**Response to the Opinion**

**In respect of a Build-to-Rent Residential Development**

**The former Aldi Site, Carmenhall Road, Sandyford Industrial Estate, Dublin 18**

**Submitted on Behalf of Sandyford GP Limited (acting in its capacity as general partner for the Sandyford Central Partnership)**

Figure 2.1: Details on Changes to Heights from the Previous Extant Permission

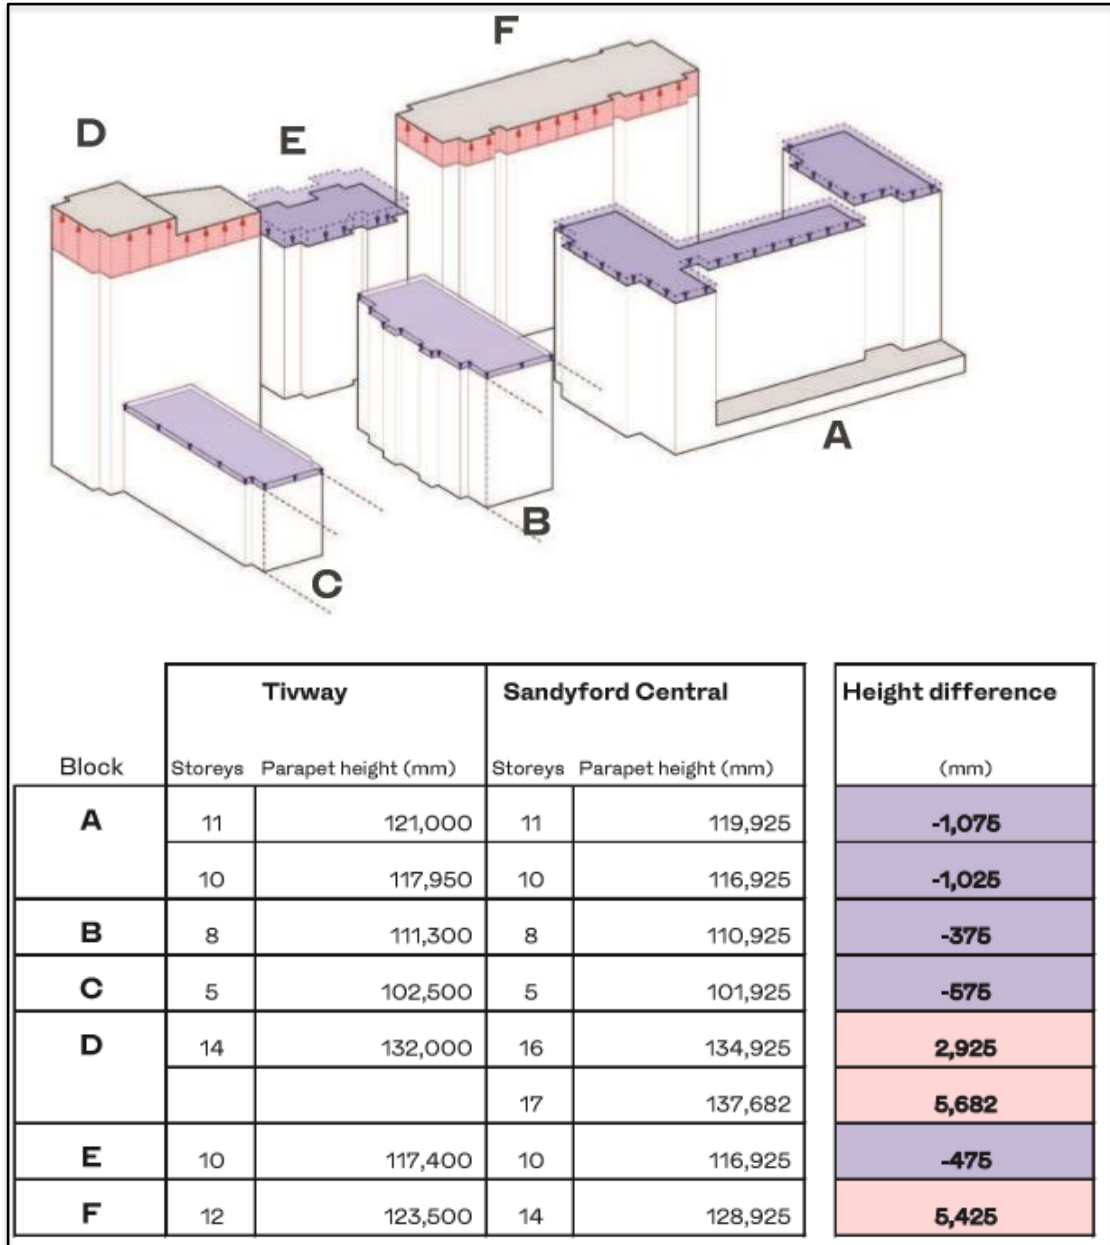
*'Further justification of the documents as they relate to building height. This justification should have regard to, inter alia, the building height parameters of the Dun Laoghaire Rathdown County Development Plan 2016–2022 (inc. Appendix 15 Sandyford Urban Framework Plan) and national guidance set out in the 'Urban Development and Building Height Guidelines for Planning Authorities' (December 2018), with particular regard to the development management and urban design criteria set in section 3.2 of the guidelines.*

The changes to the heights from the extant permission are clearly demonstrated in Figure 2.1 below which was prepared by Henry J Lyons Architects and is abstracted from their Design Statement.

The proposed Block D is part 16 to part 17 No. storeys in height and is the sole component of the proposed development that exceeds the height prescribed within the *Sandyford Urban Framework Plan 2016* which provides for a maximum of 14 No. storeys (regardless of floor to ceiling heights proposed). Block D is located to the north east corner of the subject site

We refer to the response document prepared by Henry J Lyons Architects entitled '*Response to An Bord Pleanála's Inspector's Report*' which provides further justification and architectural rationale for the increased height at Block D.

**Figure 2.4: Proposed Landscaping Materials for Various Areas.**

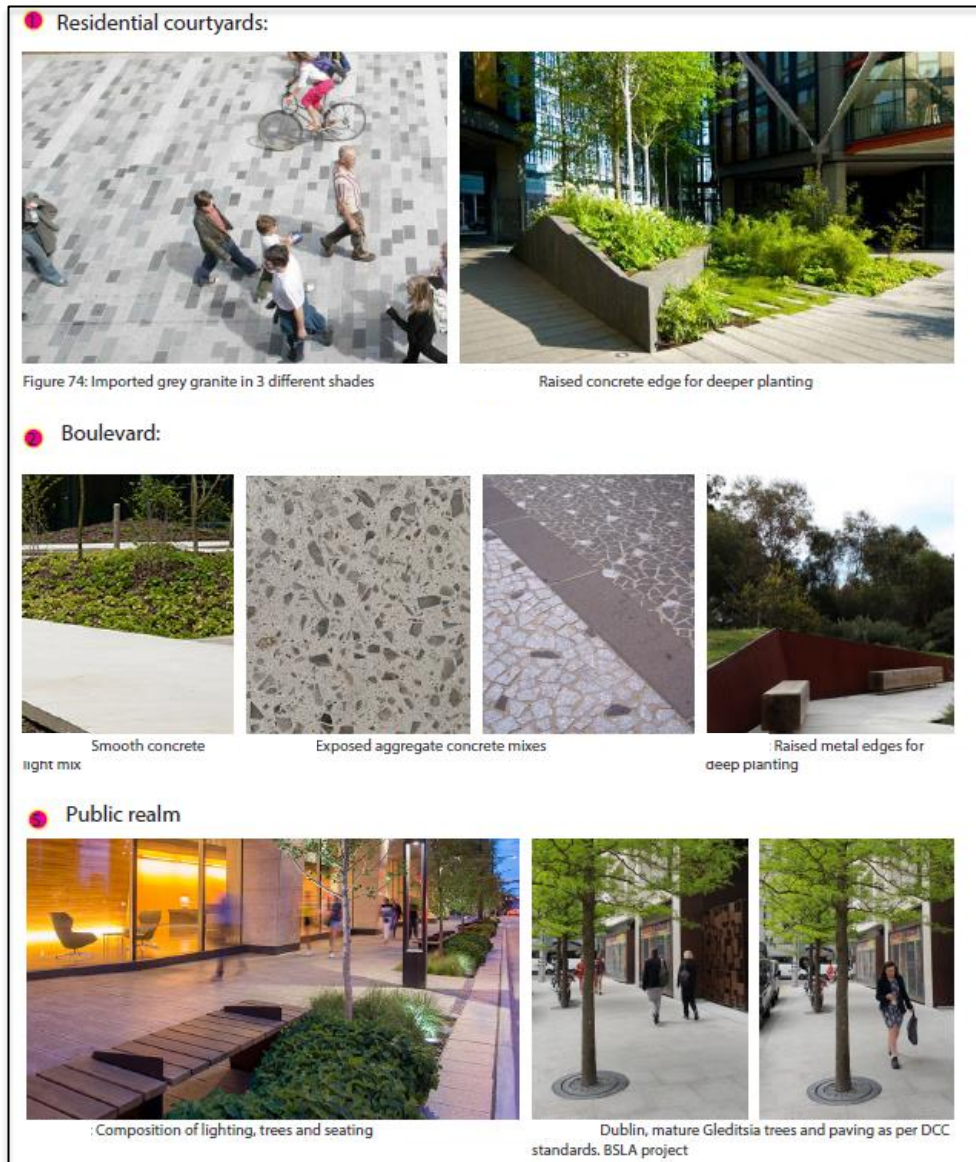
*'Further consideration/ clarification of the documents as they relate to: housing mix and the proportion of 3 – bed and larger units within the scheme; the quantum and quality of open space and amenities; the quantum and quality of communal facilities and residential support facilities and details in relation to the management of same; childcare provision in the context of the demands of the scheme and existing childcare capacity in the area; and the levels of car parking provision having regard to the demands of the scheme and the management of car parking.'*

The Landscape Report prepared by Bernard Seymour Landscape Architects demonstrates the high quality design proposed at the subject site. The key tenet of the landscaping proposal is to create a functional and enjoyable area for the residents of the scheme and the general public that will traverse through the site. Following discussions at the Section 5 Tripartite meeting a variety of play equipment appealing to a variety of ages and abilities has been introduced into the landscaping. For instance, suitable child friendly play equipment is provided within the landscaped pocket park at Blackthorn Drive, in addition to outdoor gym equipment. The variety of equipment caters for residents and visitors of different ages and abilities.

The distinction between public, communal and private spaces at ground level has been achieved through level changes and landscaping, the hierarchy of footpaths and proposed materials.
